Access Compliance Report

Public Rights-of-Way

Intersection ID: 10749	Main Street: ALLEGHANY_ST	Cross Street: FREEDOM_DR	Location: S
ADA ID: C1DF587E6E29	Ramp Type: Perp	Initial Pass/Fail: Fail	Overall Compliance: No
		Severity Score: 8.75

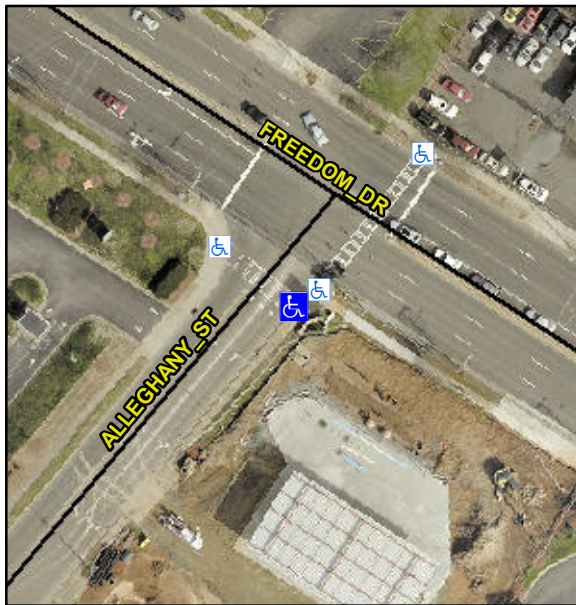
Not Found, R304.5.1

Compliance	Description	Data	Compliance	Description	Data
N/A	Ramp Length (in)	70.0	Yes	Ramp Slope (%)	5.0
No	Ramp Width (in)	47.5	Yes	Ramp XSlope (%)	0.3
N/A	Flare Type LT	N/A	N/A	Flare Type RT	N/A
N/A	Flare Slope LT (%)	N/A	N/A	Flare Slope RT (%)	N/A
N/A	Flare Traversable LT?	N/A	N/A	Flare Traversable RT?	N/A
N/A	Landing Length (in)	N/A	N/A	DWS Provided?	N/A
N/A	Landing Width (in)	N/A	N/A	DWS Contrast?	N/A
N/A	Landing Slope (%)	N/A	N/A	DWS Length (in)	N/A
N/A	Landing X Slope (%)	N/A	N/A	DWS Full Width?	N/A
N/A	Landing Curb? (Y/N)	N/A	N/A	DWS Offset (in)	N/A
N/A	Shared Landing?	N/A			
N/A	Gutter Ponding?	Yes	N/A	Gutter Slope (%)	N/A
N/A	Gutter Lip Ht (in)	0.5	N/A	Gutter X Slope (%)	N/A
N/A	Painted X Walk1?	Yes	N/A	Painted X Walk2?	N/A
	X Walk 1 Direction	To NW		X Walk 2 Direction	N/A
N/A	X Walk 1 Width (in)	102.0	N/A	X Walk 2 Width (in)	N/A
	X Walk 1 Slope (%)	6.1		X Walk 2 Slope (%)	N/A
	X Walk 1 X Slope (%)	0.7		X Walk 2 X Slope (%)	N/A

Remove & Replace Entire Ramp.
